## ADDENDUM 4

DATE: November 30, 2016  
 PROJECT: MSB First Floor Infill LRC 3 & 4  
 RFP NO: 744-R1705  
 OWNER: The University of Texas Health Science Center at Houston  
 TO: Prospective Proposers

This Addendum forms part of and modifies Proposal Documents dated, October 19, 2016, with amendments and additions noted below.

### Door and Window Details

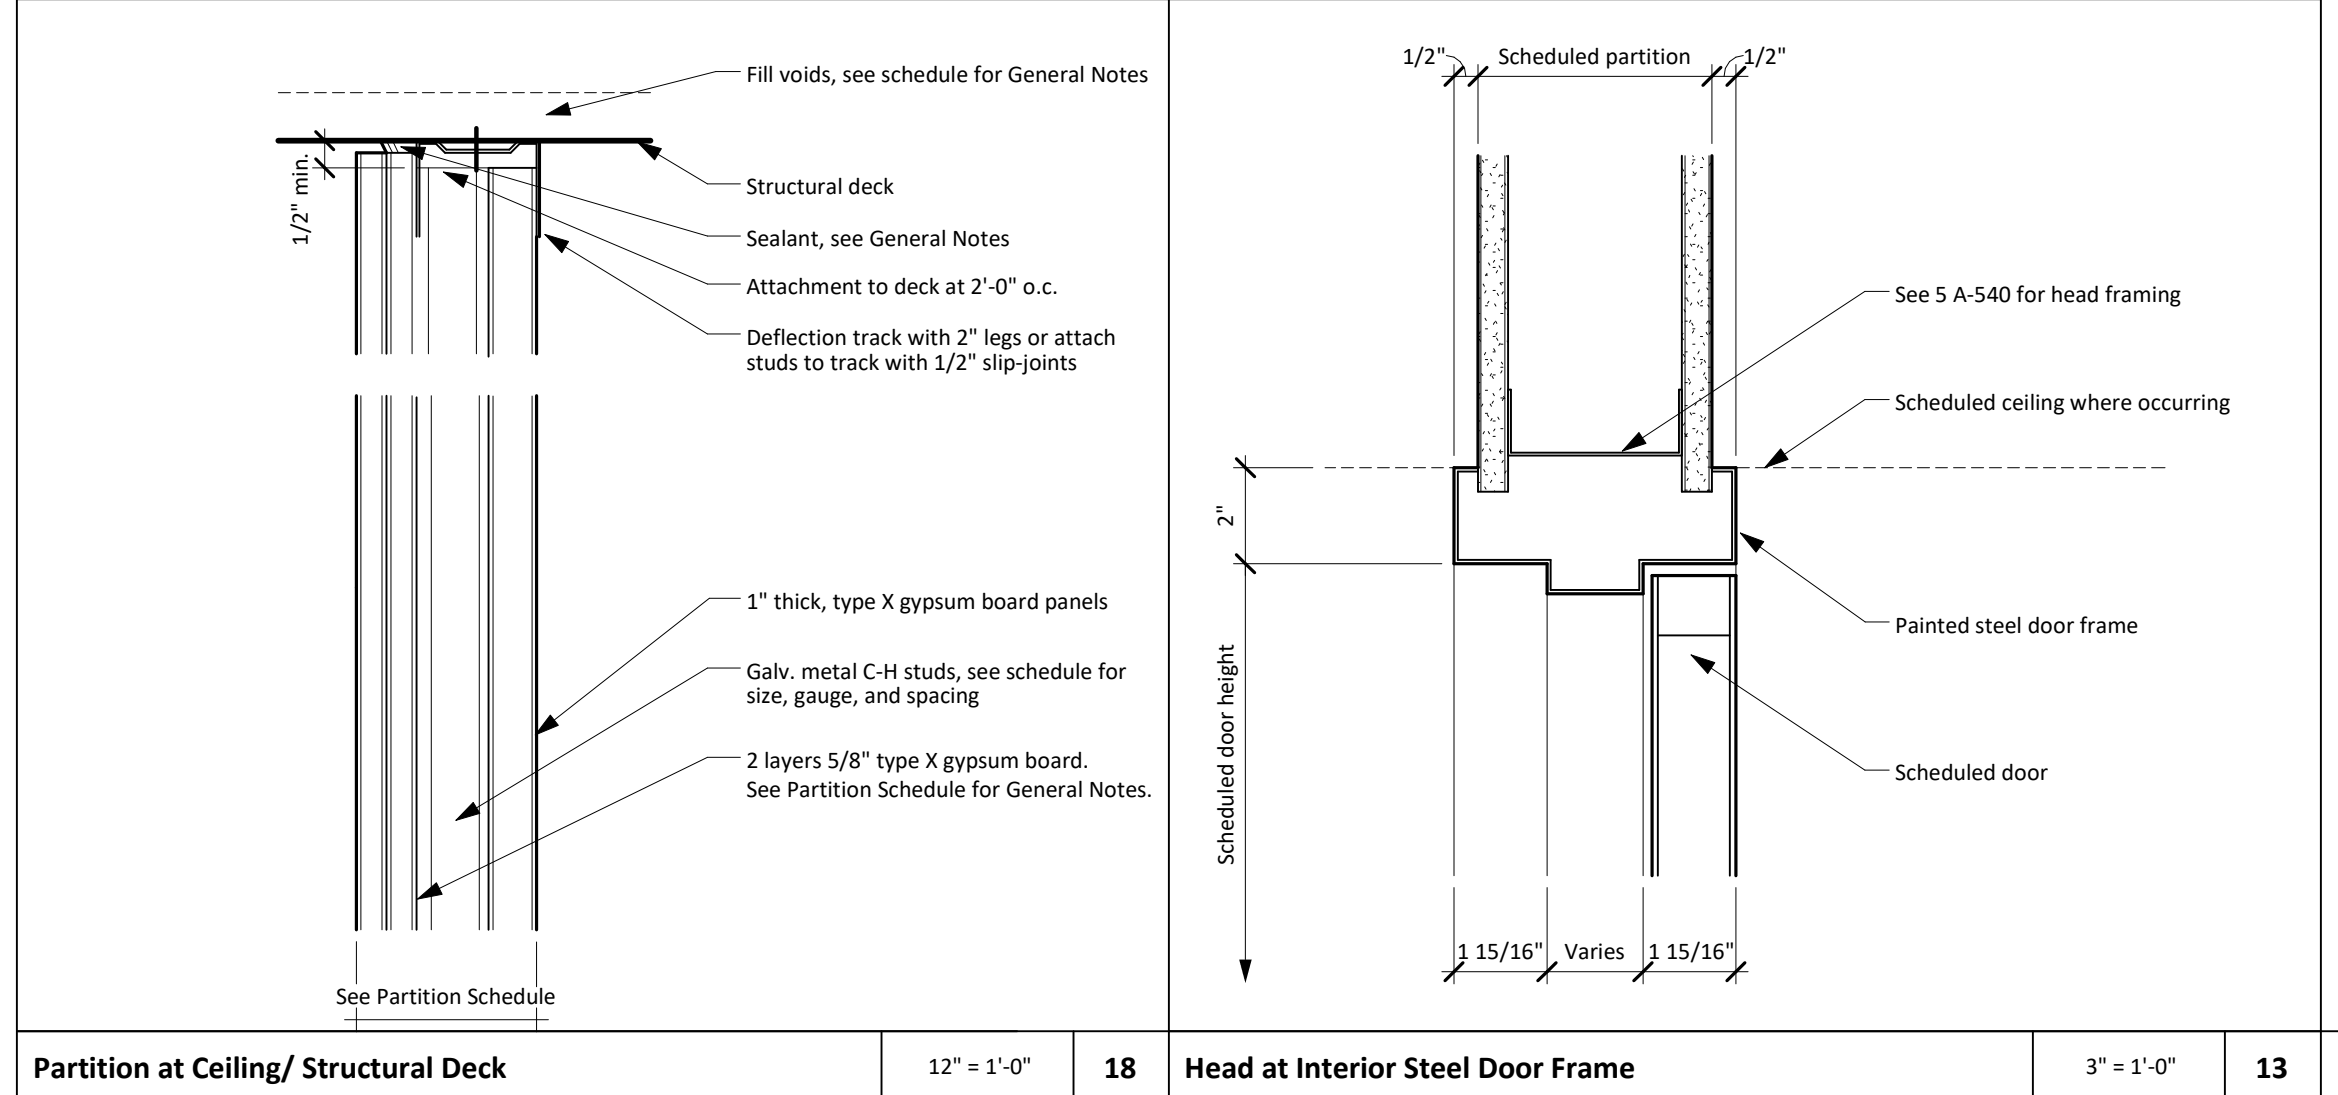
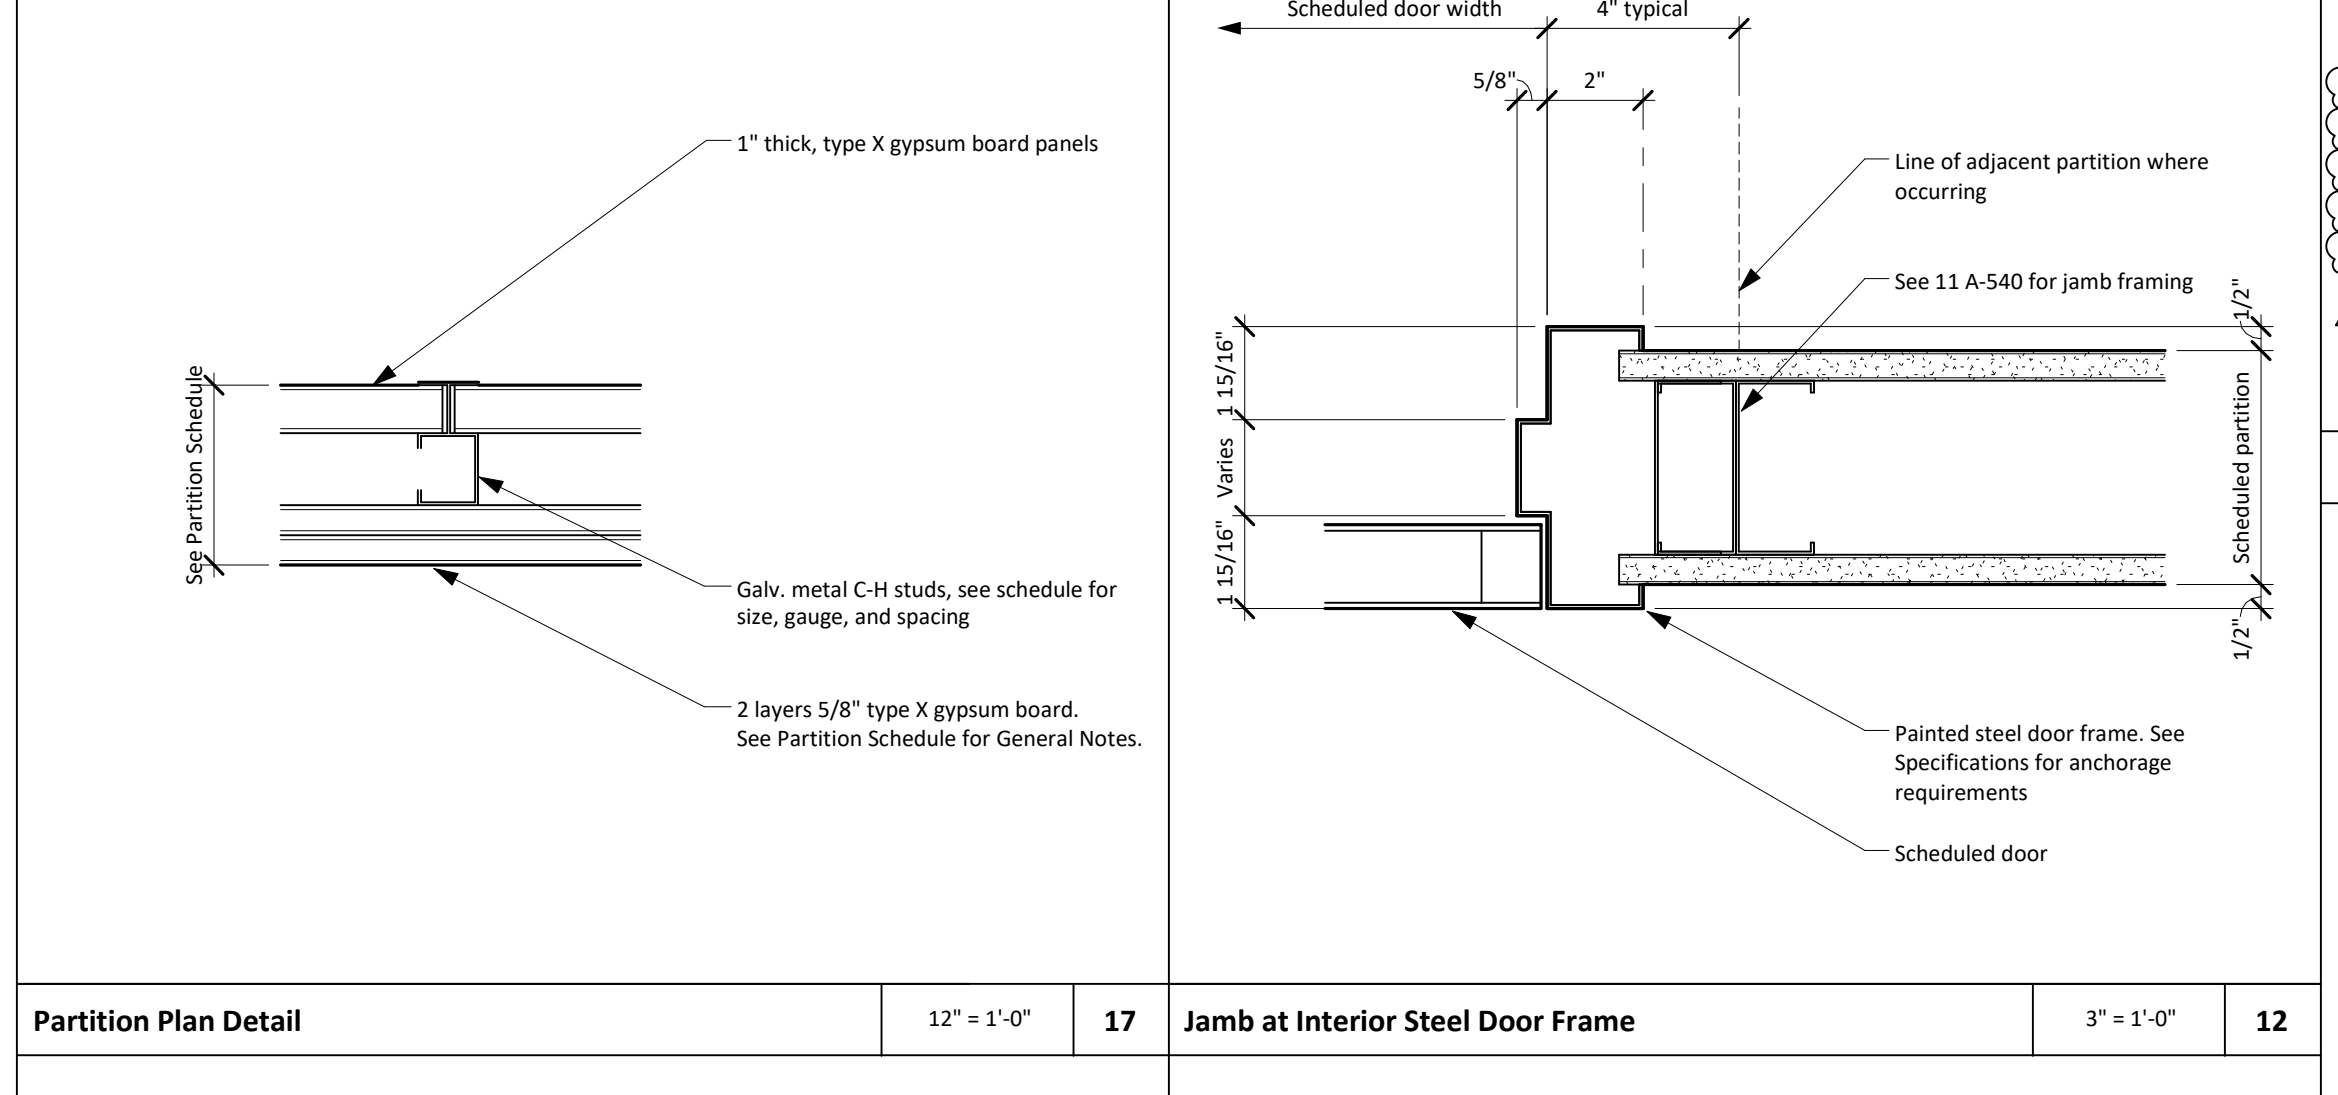
1. Please clarify the design intent for F13 as noted in ADD 03
  - a. Room Finish Schedule, sheet A-540 calls out material as CPT-2

- b. Finish Material Schedule, sheet A-540 only calls out a change to CPT-1 & VCT-1

4. Please confirm the door pattern/line and color shown on Drawing A-540 are to be installed on both ground floor and 1<sup>st</sup> floor.  
**Doors on ground floor are to be existing. No new doors at this level.**

**CPT2 (9223 Hops) will not be used at Level 1; it will be omitted.**

**CPT2 will be omitted.**
